ADVISORY NEIGHBORHOOD COMMISSION 3D

June 27, 2016

**RE: BZA Case No. 19274 – Appeal of Zoning Administrator Determination on
Parking Considerations with the Proposed Construction of a New Building at the
Spring Valley Shopping Center (Square 1500, Lots 1, 2, and 3)**

**Engineering Designs Of Parking Lot 1988-1989
(ANC Application Attachment C)**

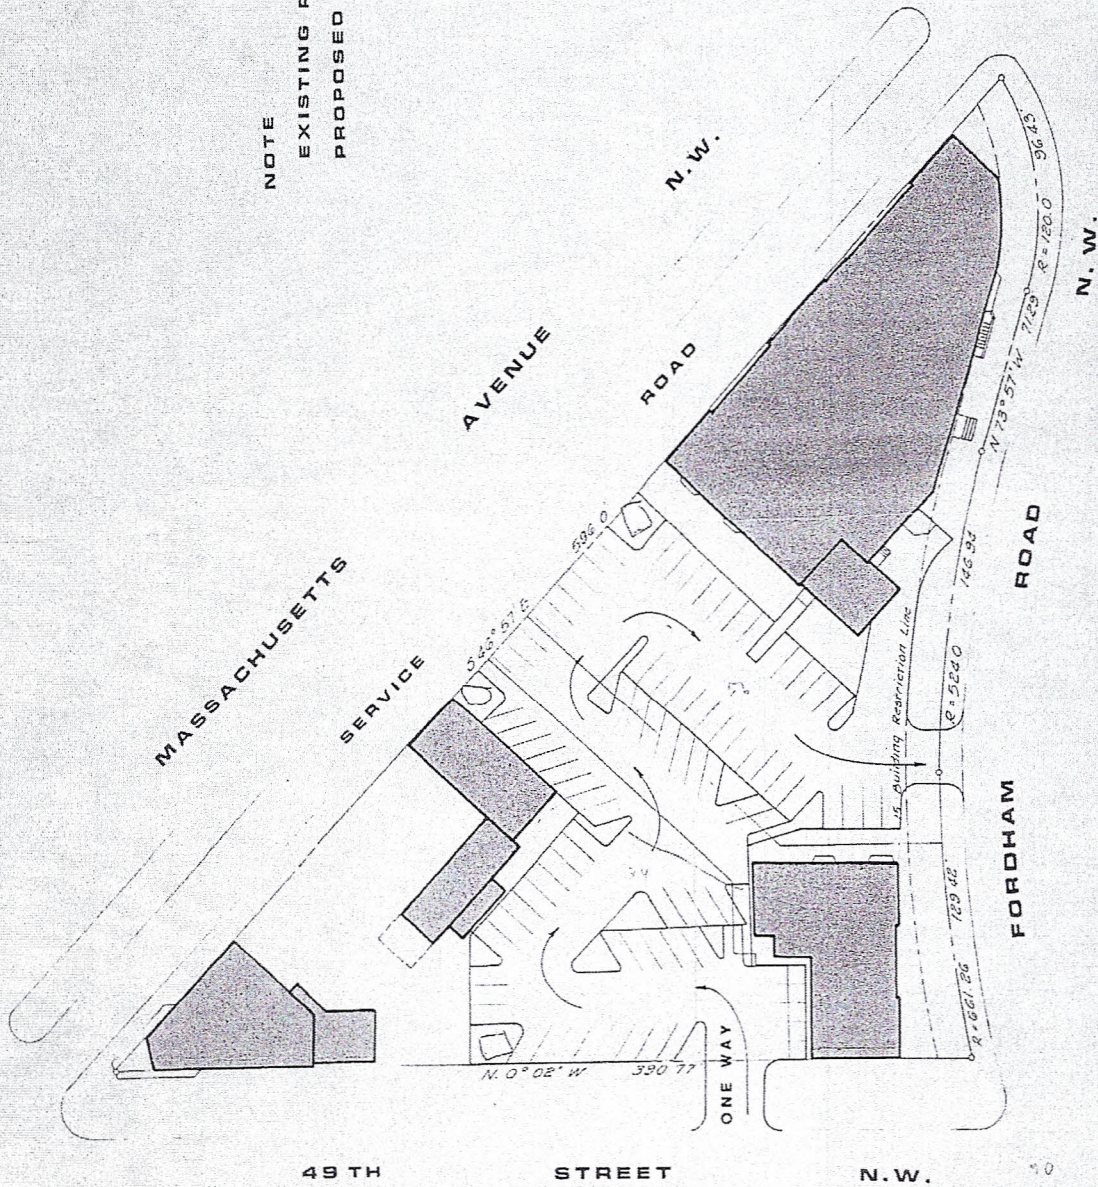
An engineering plan prepared by the former owner of the site just before the site was designated a Historic Landmark – and provided to the ZA in advance of his determination – shows the parking lot had 77 parking spaces and that it was being expanded to 90 spaces.

(Exhibit 4) Moreover, this design of the parking lot, as it existed in 1987, shows that the parking lot had 77 spaces and that none of these spaces crossed the building restriction line into public space.

So, it was the property owner's choice – not by necessity – to locate parking spaces partially in public space in order to provide the 77 parking spaces. There is no basis to hold that the Zoning Regulations now exempt the property owner for choosing a parking lot configuration that failed to comply with the public space requirements.

**Spring Valley Shopping Center
1963 Aerial Photo**

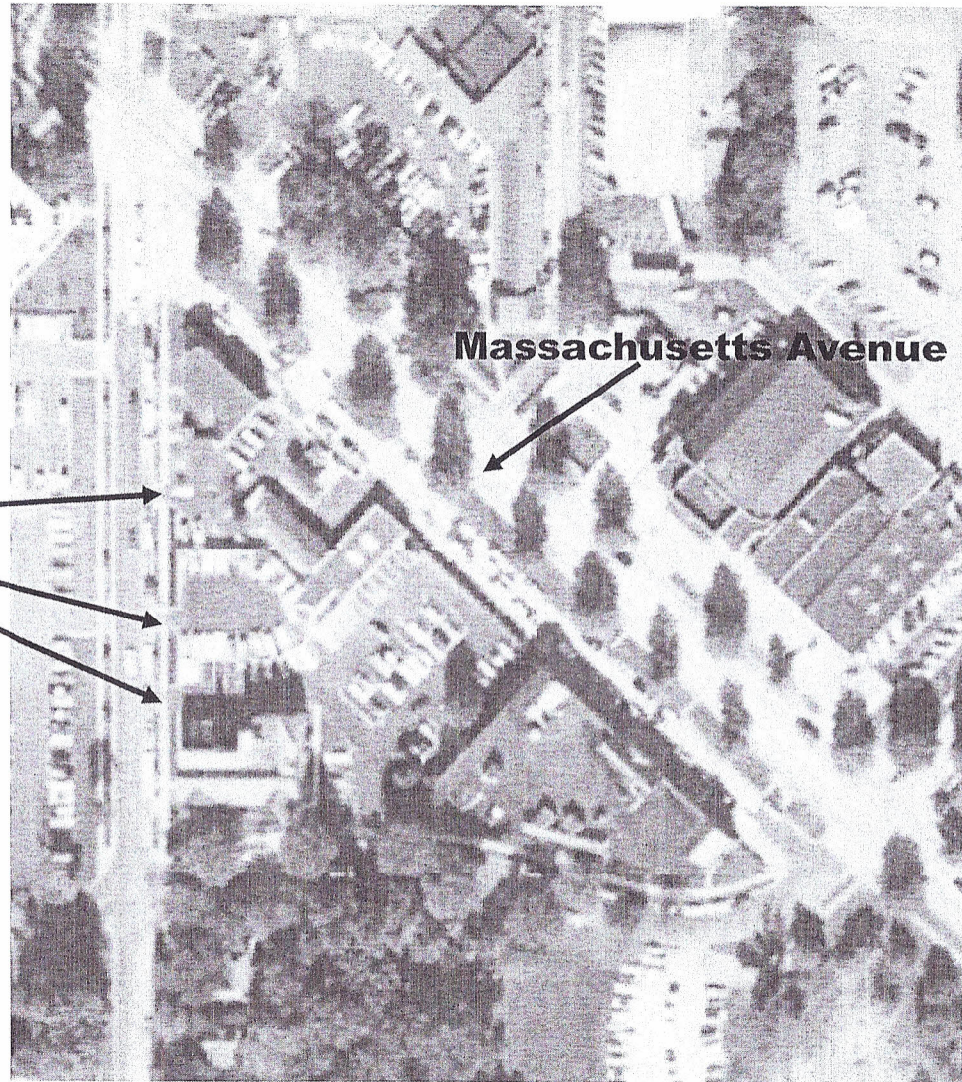
However, the parking area that now is determined to intrude into public space has been used for parking since at least 1957, according to aerial photographs (**Exhibit 10**) of the site. This pre-dates the Zoning Regulations and the public space rules. Not only were parking spaces configured at this location, this area now used for parking was designated as an entrance/exit for the parking lot dating back at least to 1949 (**Exhibit 10**). The curb cuts for the parking lot entrance/exit are still in place today.
